July 2, 2015  
 Alberta Technology Center  
 Owner: The City of Tuscaloosa  
 Owner's Project No: A15-0513  
 Architect: Ward Scott Architecture, Inc.

This Addendum forms a part of the Contract Documents and modifies the original Bid Documents dated June 22, 2015, as noted below.

**Addendum No. 3 - Structural Items**  
**July 2, 2015**

JOB NO. 12689.000 SHEET NO. SD-1  
BY T. MEYER DATE 07/02/15  
CHKD BY S. DOLLAR DATE 07/02/15

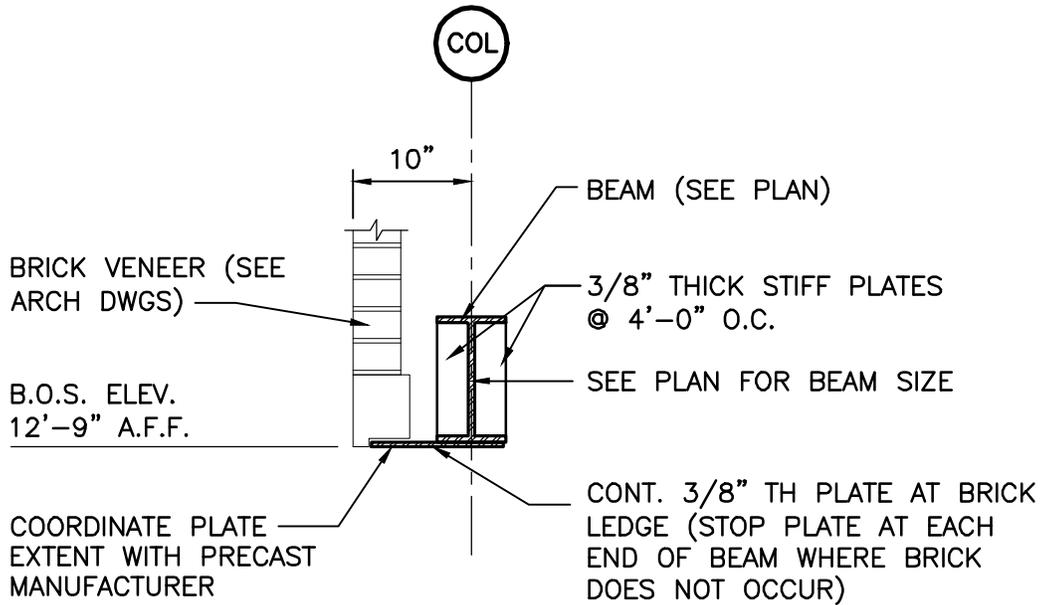
1. Revised bottom of steel elevation and clarified bottom plate extents on section 14/S002. Reference the attached supplement drawing SD-1.
2. Do not extend slab edge at door openings as shown on sheet S101 – Foundation and First Floor Plan. Slab edges at door openings shall align with adjacent slab edges.
3. Revise all W10x45 beams shown on S102 to W10x30's.
4. Eliminate the note reference to wall metal panels on details 1, 2, 8, 9, 10, and 11 on sheet S201. Reference architectural drawings for all wall finishes.

S104

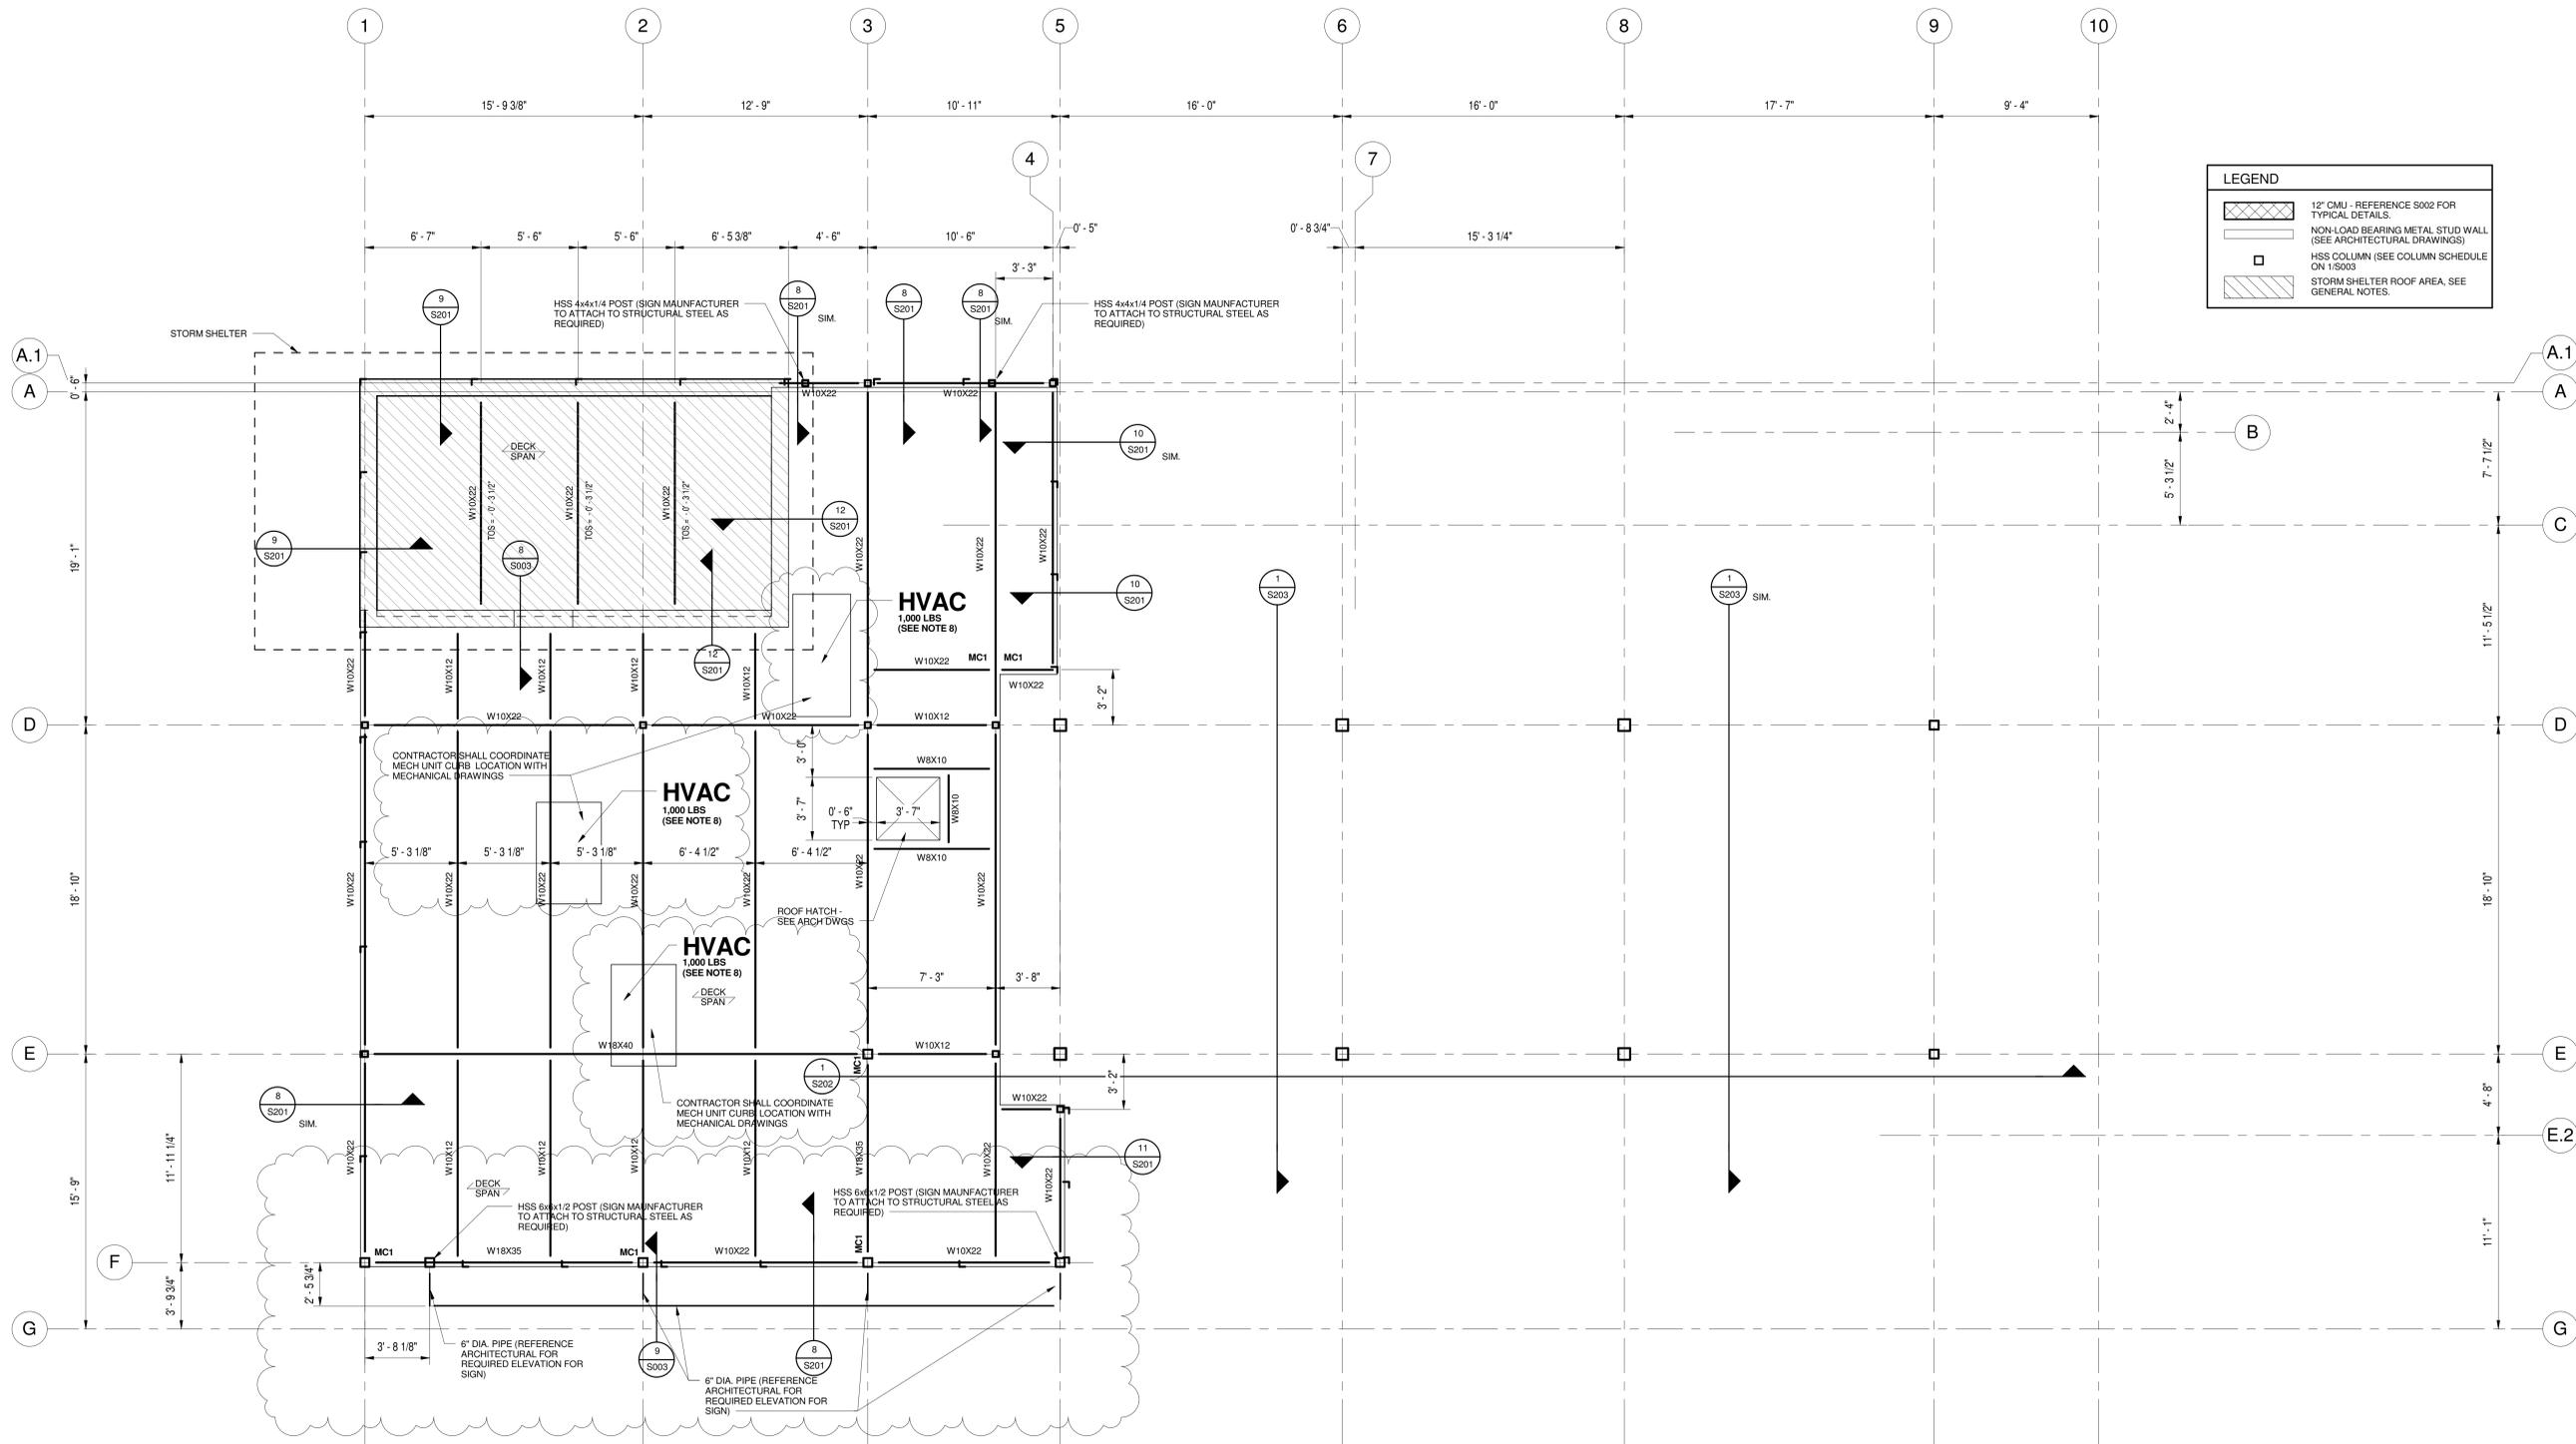
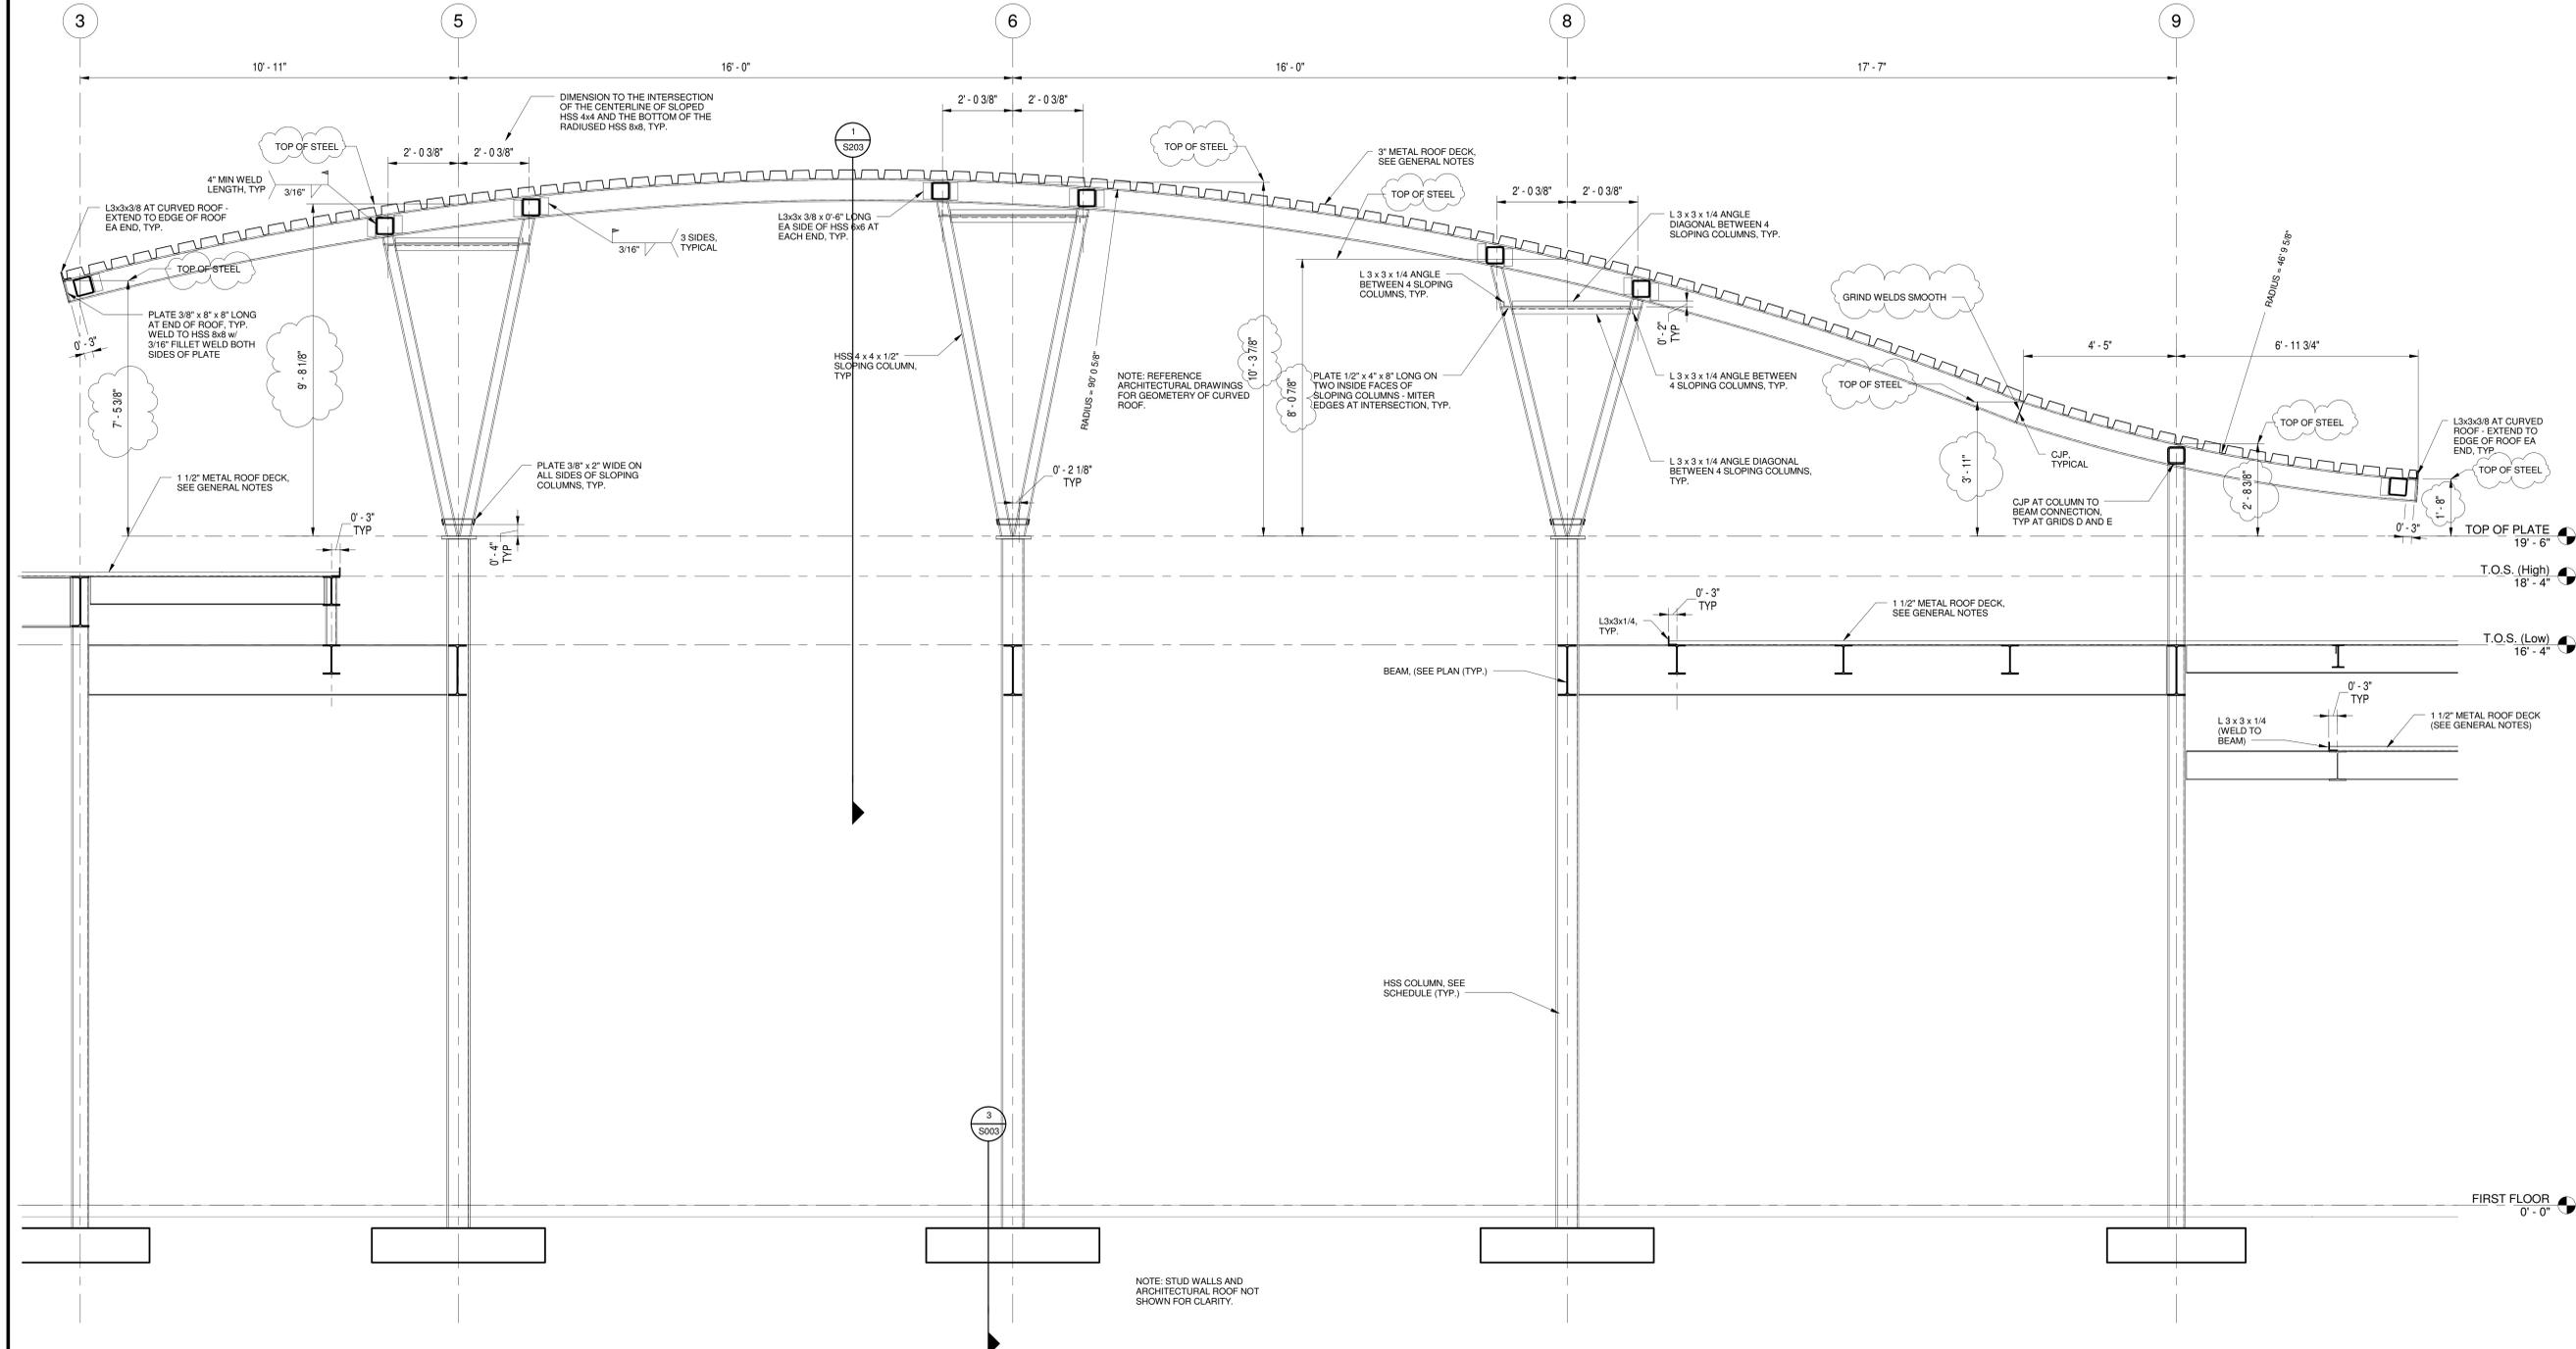
**II. Sheet S104 – High Roof Framing Plan**

1. Revised sign support extents.
2. Revised roof-top mechanical equipment locations and added notes for contractor to coordinate the mechanical curb support and locations with the mechanical drawings.

BID SET		
DATE:	06/22/15	
PROJ NO:	14-028	
REVISIONS		
#	DESC	DATE
1	ADDEND.	7/2/15
#3		
SECTIONS		
S203

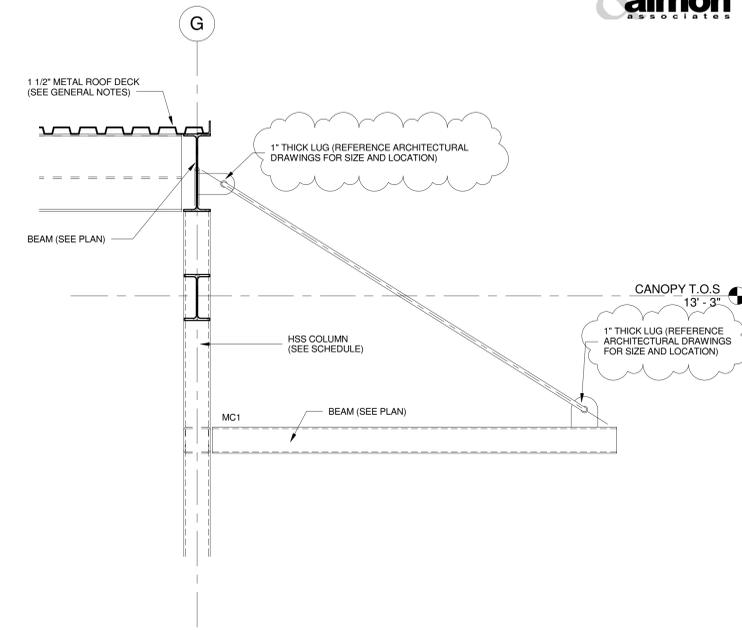
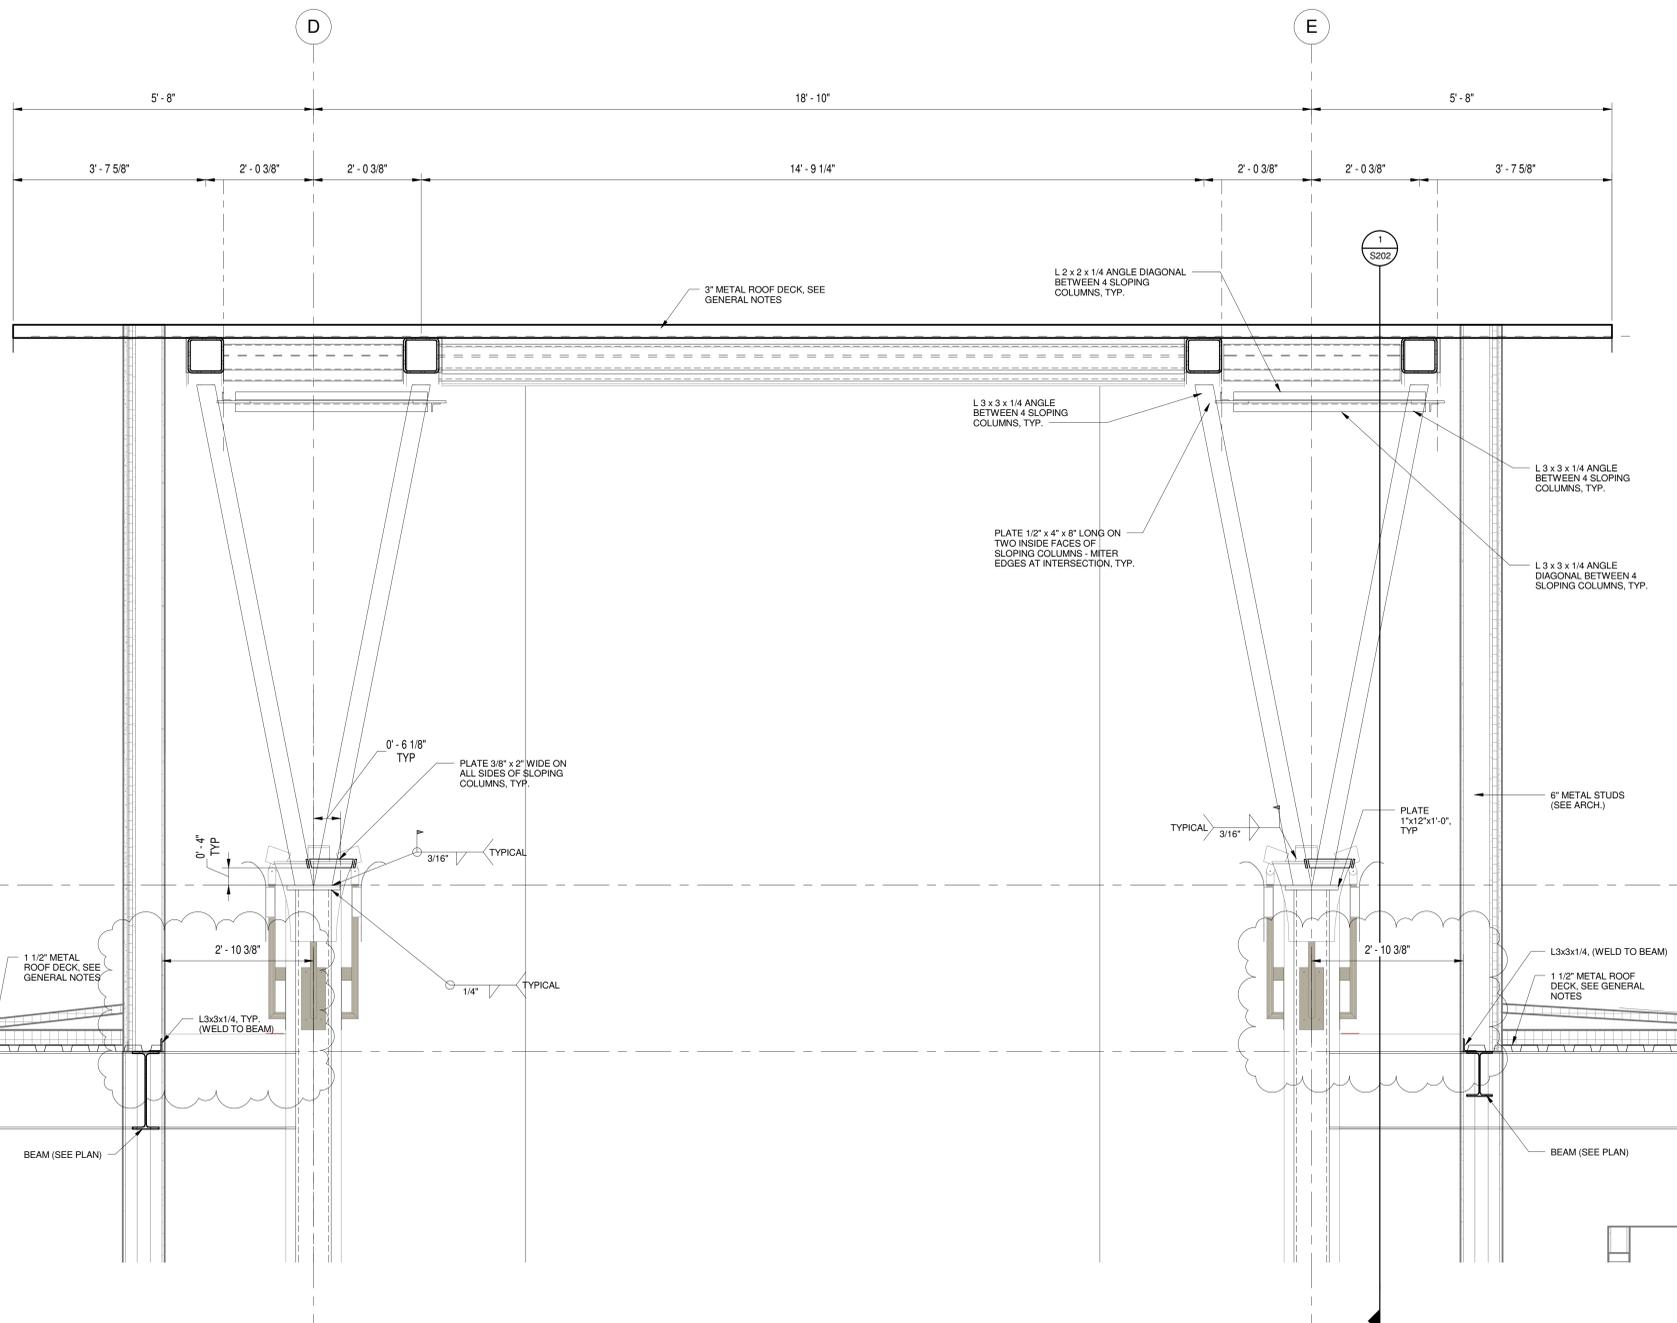
**IV. Sheet S203 – Sections**

1. Revised edge angle locations on section 1/S203.
2. Added note to 2/S203 for the contractor to reference the architectural drawings for the size and location of the 1" thick lugs.
